**PROJECT: Eaton, Somerset, Willard, and Washington Sewer
Projects, City of Ferndale**

**EATON, SOMERSET, WILLARD, AND WASHINGTON SEWER
PROJECT NO. SS2011-01**

ADDENDUM NO. 1
To the Contract Provisions for
City of Ferndale, Washington

**EATON, SOMERSET, WILLARD, AND WASHINGTON SEWER
PROJECT NO. SS2011-01**

PIPE ZONE BEDDING AND BACKFILL
STANDARD PLAN B-55.20-00
 SHEET 1 OF 1 SHEET

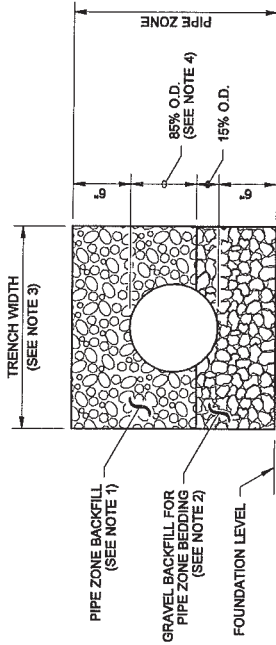
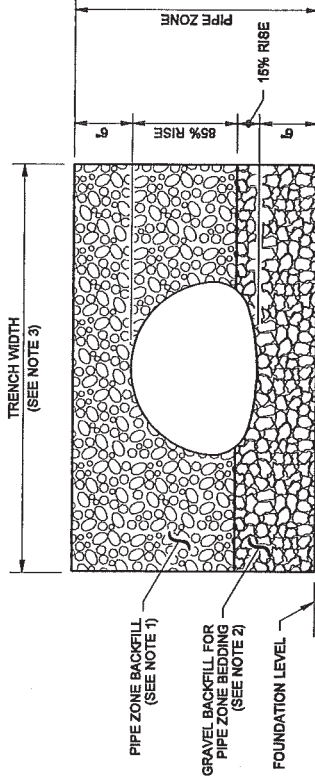
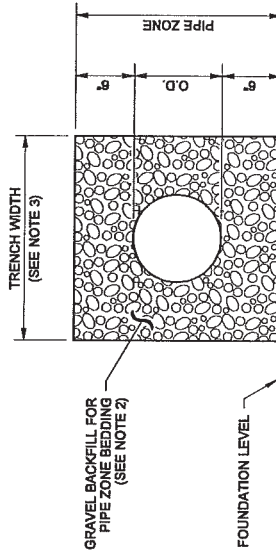
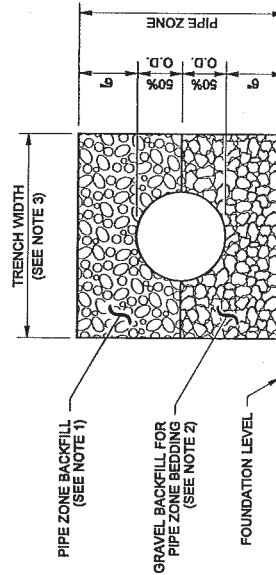
The attached WSDOT Standard Plan B-55.20-00 is added for reference.

EATON, SOMERSET, WILLARD AND WASHINGTON SEWER PROJECT
PROPOSED SANITARY SEWER ALTERNATE A1

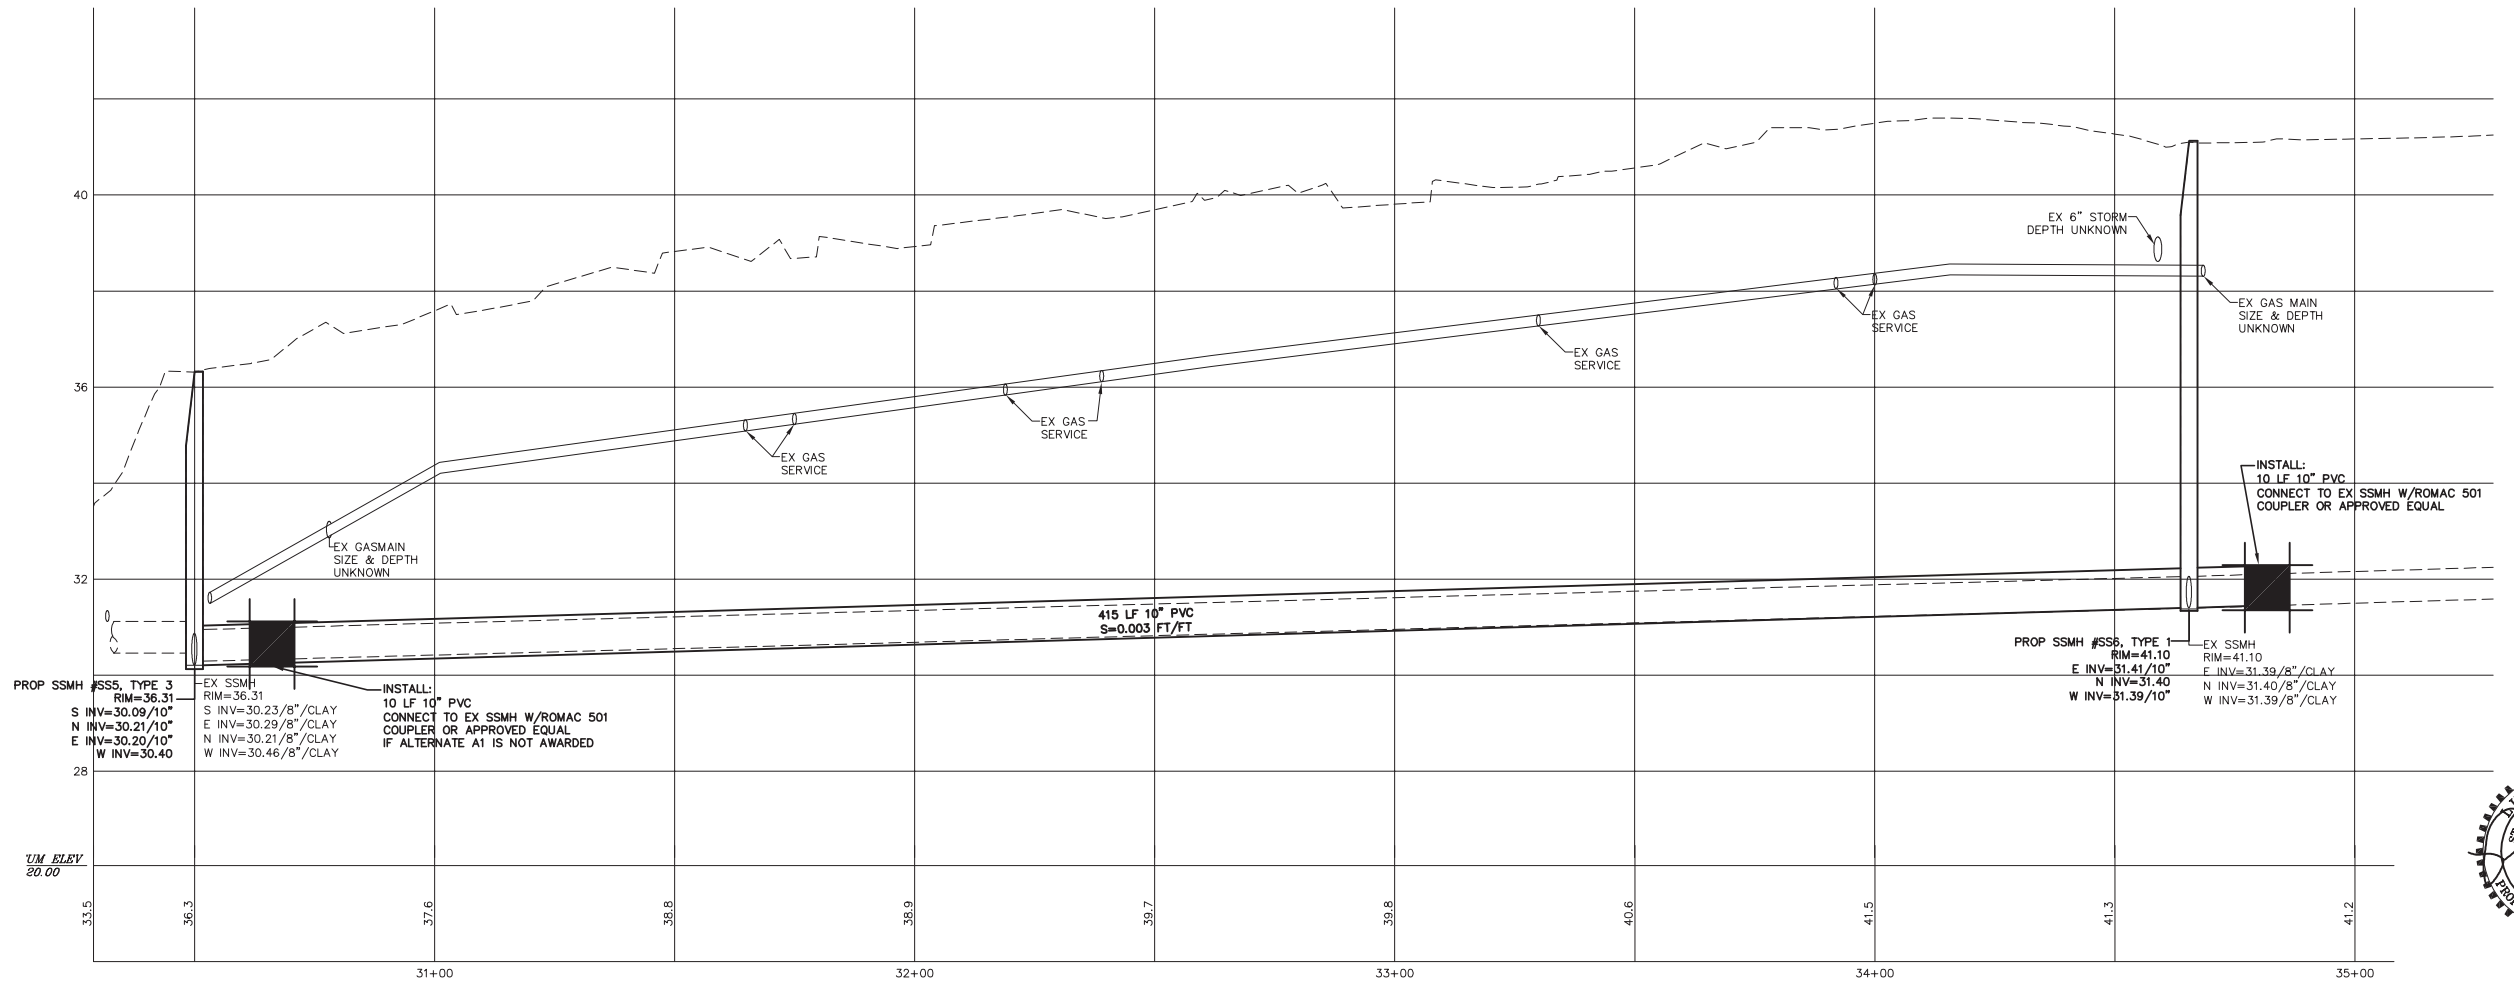
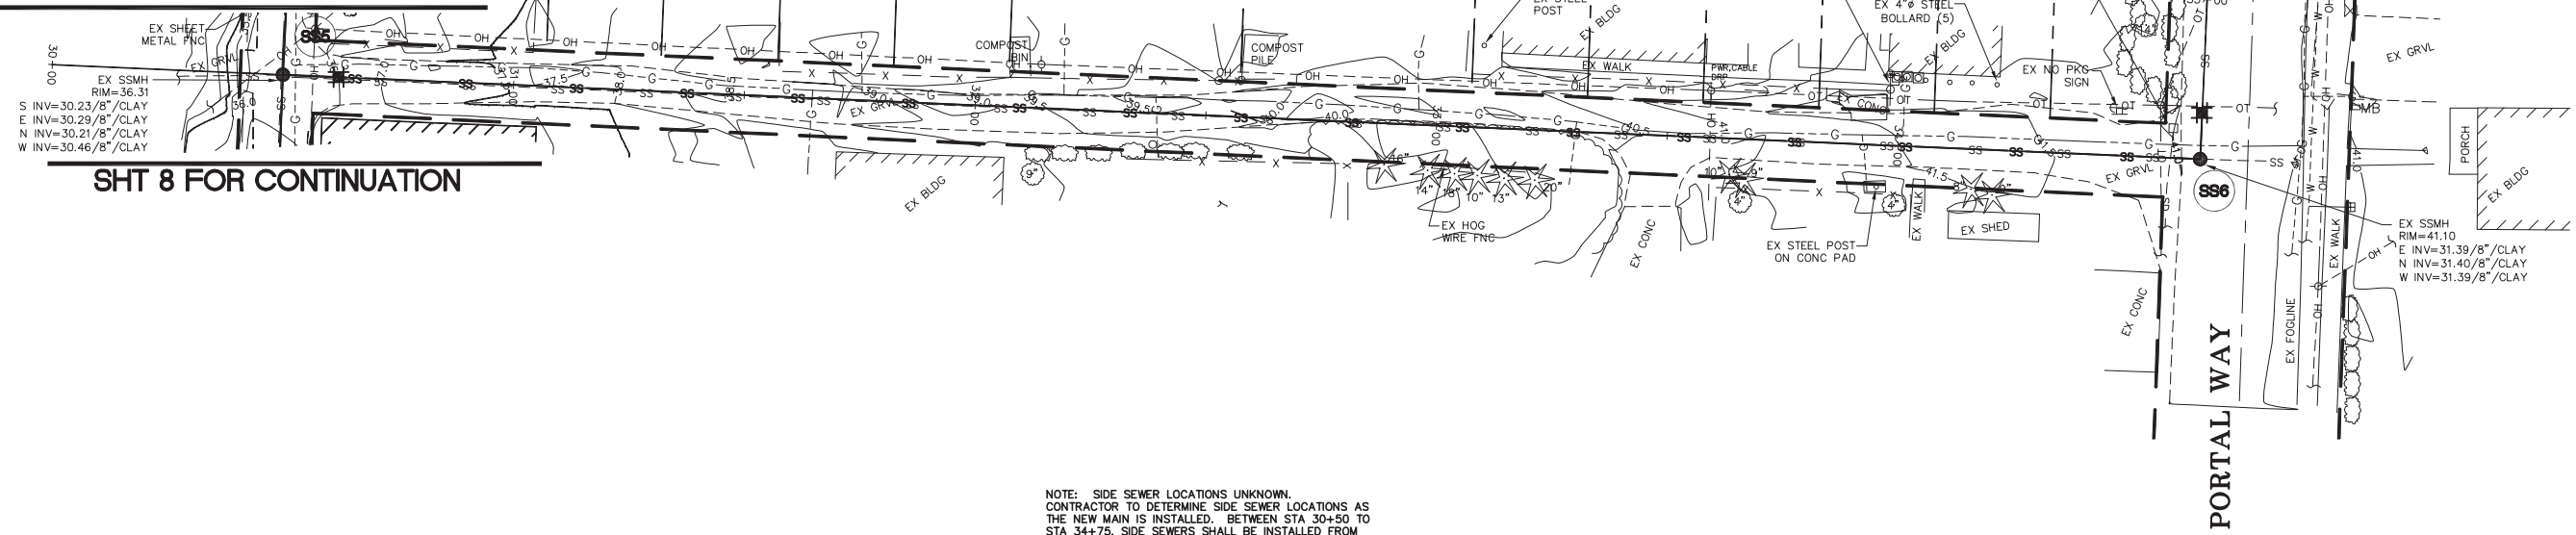
Bid Proposal Form, Alternate A1 Bid Items have been adjusted as the project limits for Alternate A1 have been reduced. Alternate A1 work shall end just north of SSMH #SS6 as shown on the Plans.

Alternate A1 work shall end just north of SSMH #SS6. The attached Plan Sheets reflect this revision. The attached Plan Sheets shall replace the original Plan Sheets.
